**SUBJECT:** Approve Contract Change Order No. 1, Palm Springs MDP Line 43 and Lateral 43A, Stage 1, Project No. 6-0-00163, District 4 [\$356,411] District Funds 20%

Project: Palm Springs MDP Line 43 and Lateral 43A, Stage 1  
Project No. 6-0-00163-01

**CONTRACT CHANGE ORDER NO. 1**

REVISED PAVING LIMITS

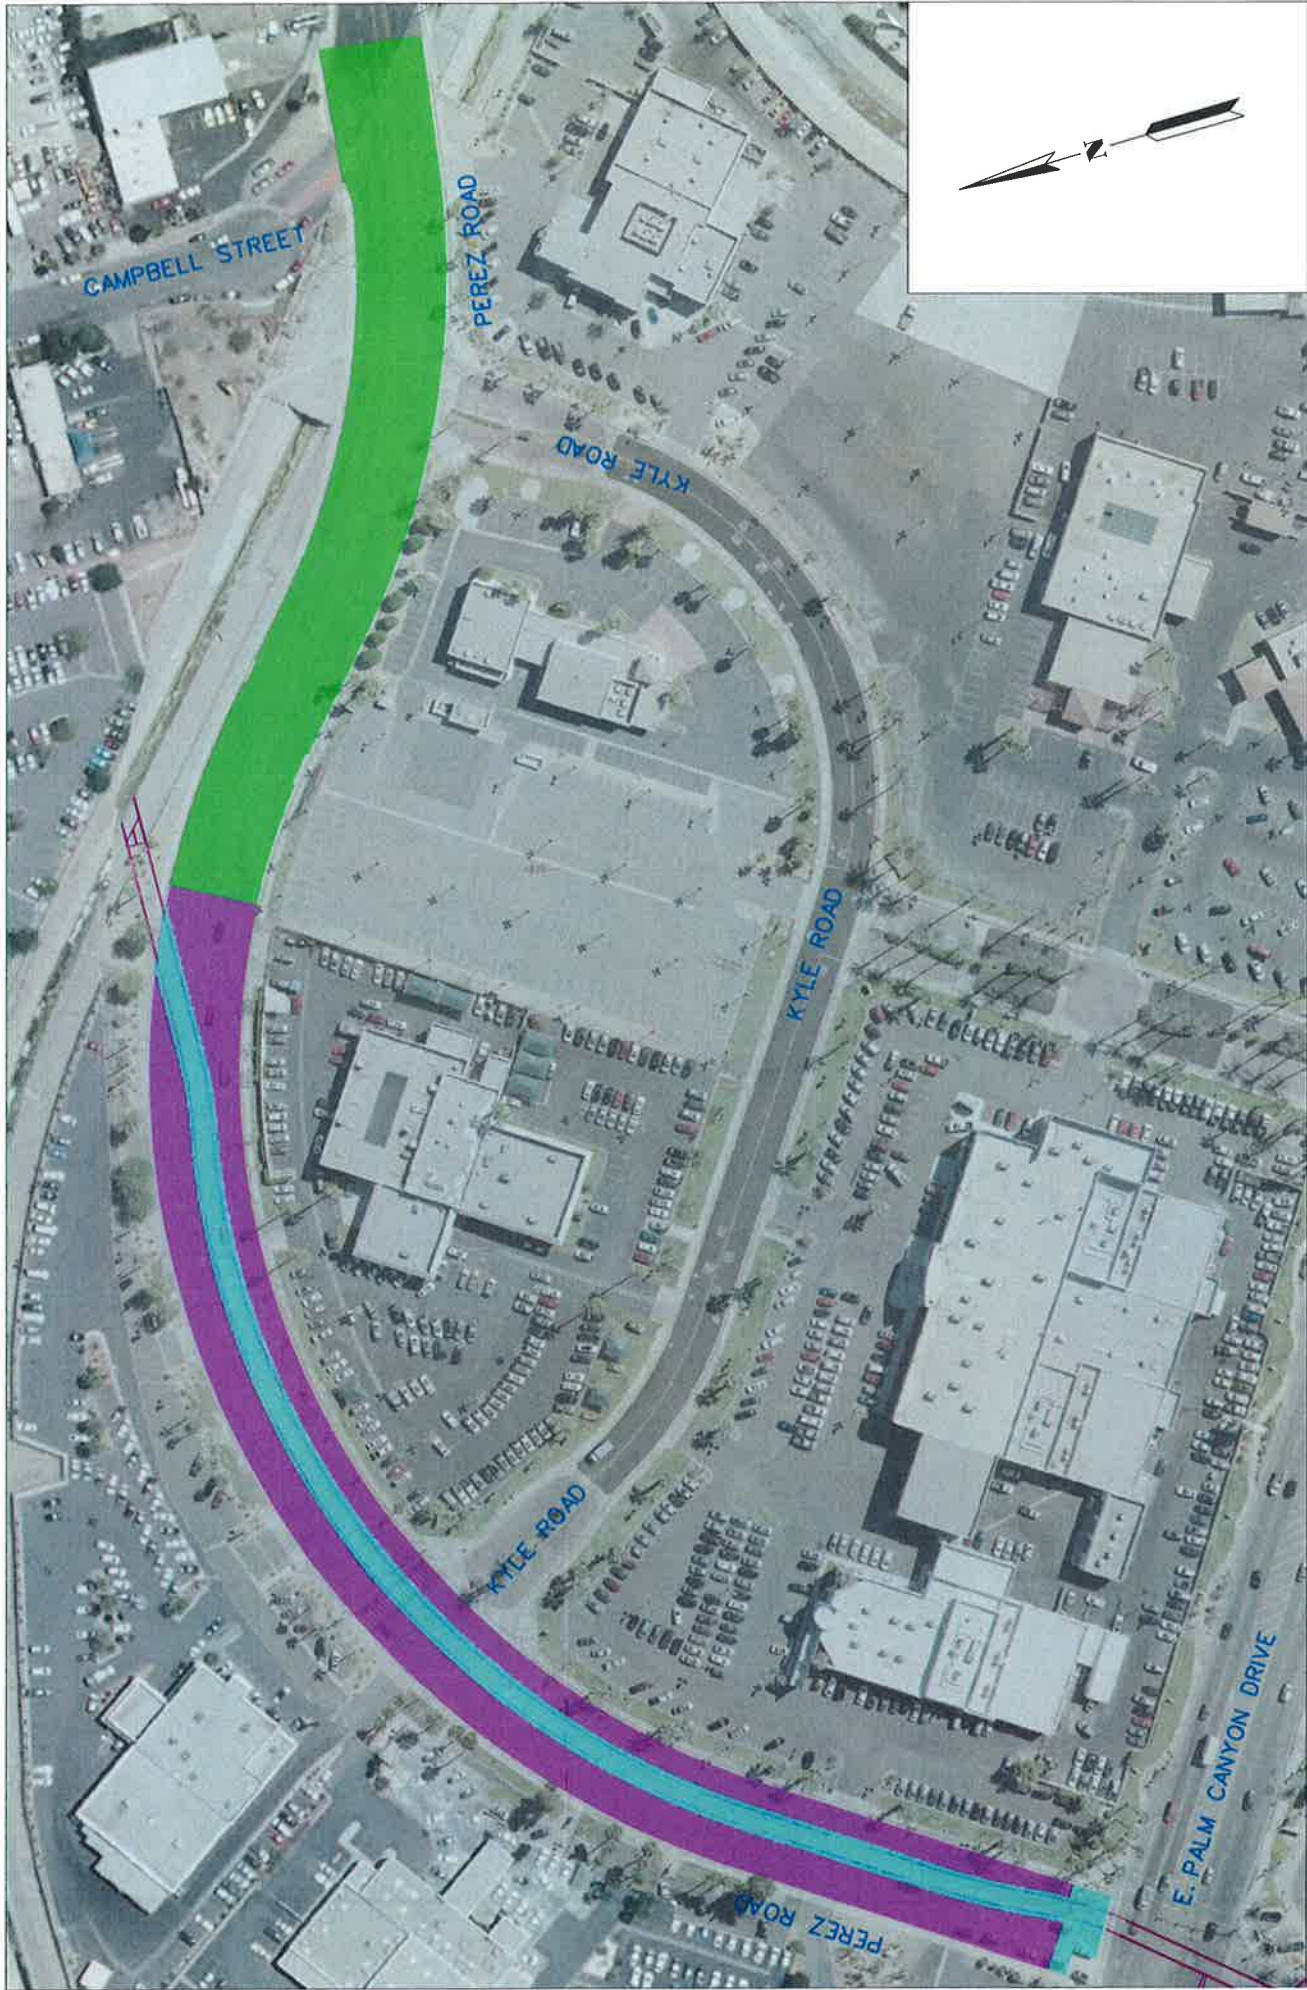
1. Per the City of Cathedral City's request, the Contractor was directed to extend the paving limits along Perez Road, north of East Palm Canyon Drive, from the downstream end of the project northerly to Campbell Street. The additional paving extends the full width of Perez Road and entails the removal and replacement of the top four (4) inches of existing pavement. The associated lump sum cost for the Extra Work is \$163,810.94 and shall be paid for solely by the City of Cathedral City.

2. Per the City of Cathedral City's request, the Contractor was directed to extend the paving width on Perez Road, north of East Palm Canyon Drive, from the edge of the District's trench limits to the full width of Perez Road. The additional paving extends the full width of Perez Road and entails the removal and replacement of the top four (4) inches of existing pavement from the beginning of the project to East Palm Canyon Drive.

Due to the Contractor's construction activities exacerbating wear and tear on the existing pavement on Perez Road, the District agreed to contribute an amount not to exceed \$72,376.95 toward the additional paving. The basis of the District's contribution corresponds to half the cost of a two (2) inch grind and overlay for the expanded limits. The associated lump sum cost for this Extra Work is \$192,600.71 with \$120,223.76 paid for by the City of Cathedral City.
